JOHN HUNTER HEALTH & INNOVATION PRECINCT
SSDA
ARCHITECTURAL DESIGN STATEMENT - RESPONSE TO SUBMISSIONS

RESPONSE TO SUBMISSIONS

CYCLING, BUSH WALKING AND NEWCASTLE INNER CITY BYPASS LOOKOUT ROAD CONNECTION - EXTENDED CONTEXT

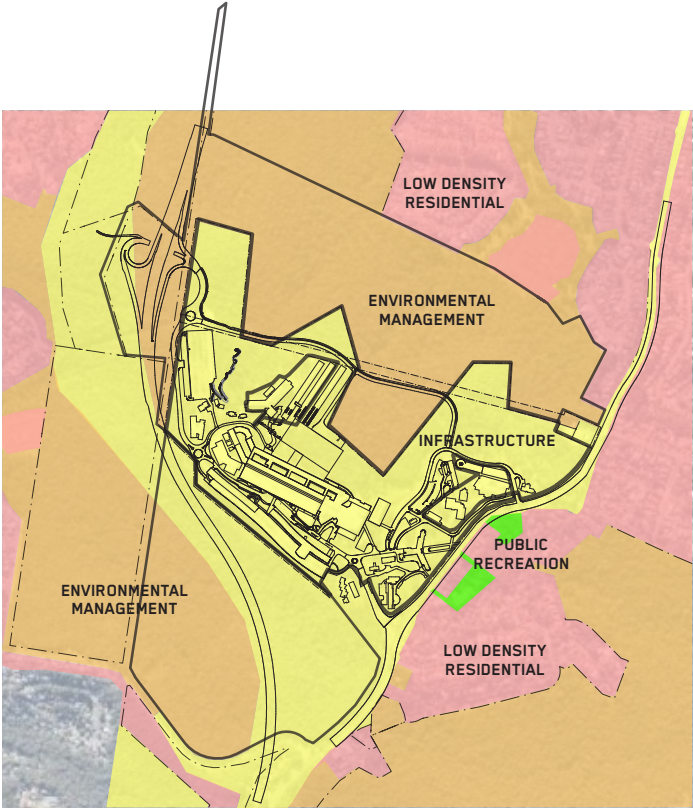
Agency	Submission	Relevant Section
Department of Planning	Additional Information	
	4. Provide the following additional information:	
	a plan of the proposed new road network in a wider context including the Newcastle Inner City Bypass and interchange and Lookout Road.	1.0 Environmental Analysis & Site Layout
	a land use zoning plan with an overlay showing the development footprint and associated roadworks.	1.0 Environmental Analysis & Site Layout
	a plan showing the existing cycling and bushwalking tracks in the vicinity of the site.	1.0 Environmental Analysis & Site Layout

End of Trip facilities are provided for staff within the semi-basement ASB car park. This location offers ready access to the cycleway through Jesmond Bushland to the north, with immediate connection to the lifts of the ASB. Facility calculations have been determined based on populations for the ASB. Further detail can be found in the appended drawing set - Basement 4 plan.

Public bicycle parking is provided adjacent the main entry to the JHH. The area is provided with a canopy for weather protection, and is in sight of the entry doors, ensuring passive surveillance is provided. Further detail can be found in the appended drawing set - Level 02 plan.

4.0 SHADOW STUDIES

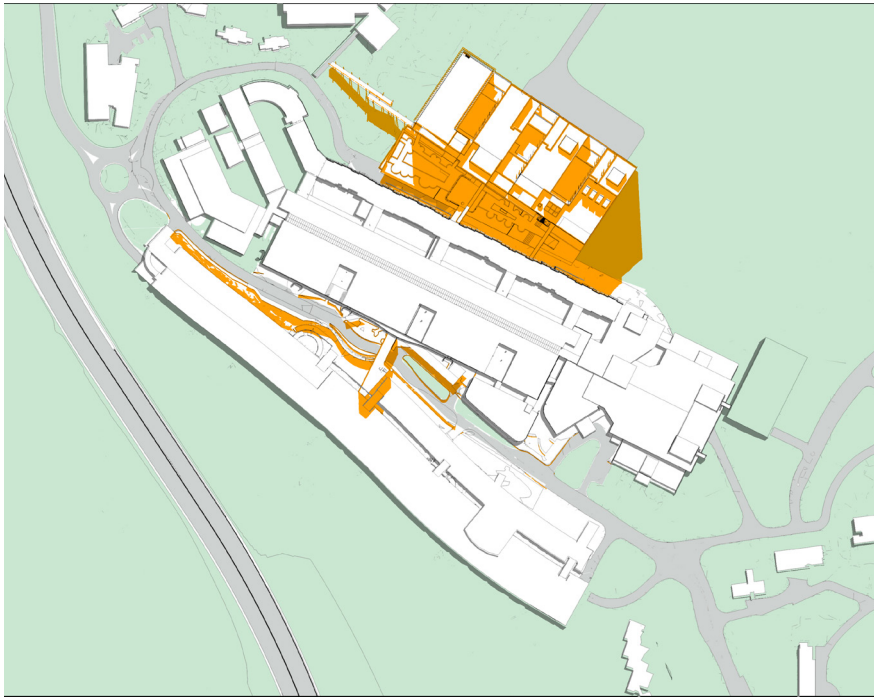
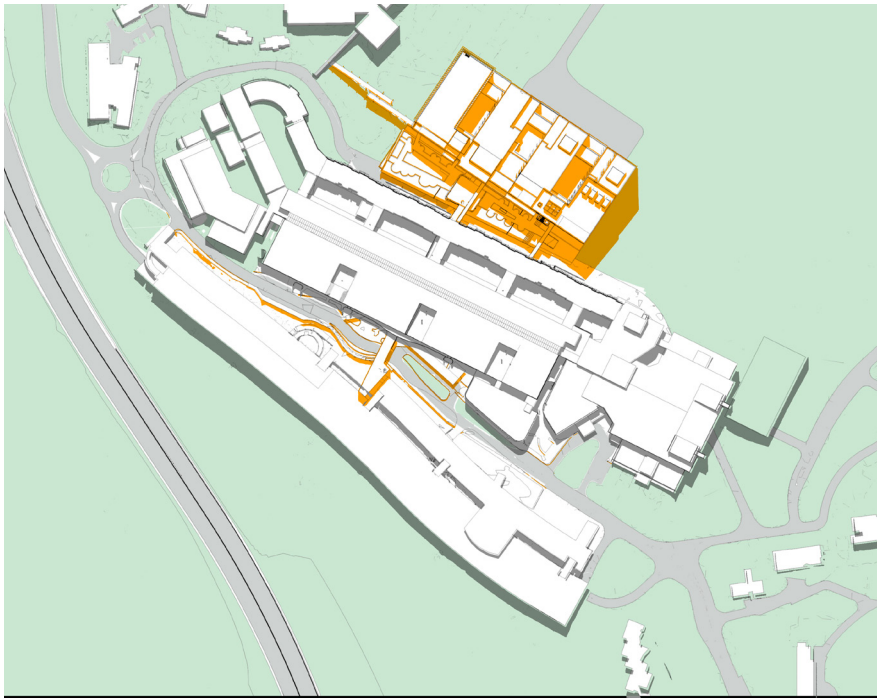
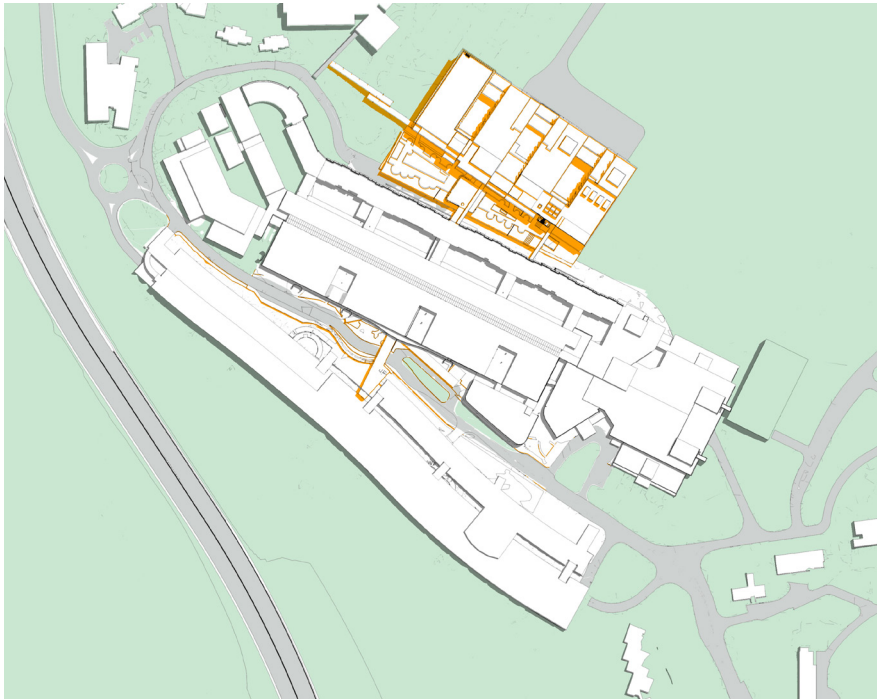
Updated shadow studies	4.0 Shadow Studies

Shadow studies have been prepared to illustrate the impacts both to the new development and to the existing built form on the site. Achieving a high level of amenity in both areas is important and has been considered as the design has progressed to this stage. The rotation of the ASB footprint not only provides a greater space for the elevated garden and creates closer proximity and connection to the HMRI building adjacent, it also reduces the overall impact of the built-form of the ASB on the existing building.

Solar access and self-shading has been an important consideration as the building form has developed to achieve a balance between access to views and natural light, and the impact on building performance that heat loss and gain can have. These aspects have been reviewed and refined through close consultation of the design team, particularly the ESD and mechanical consultant.
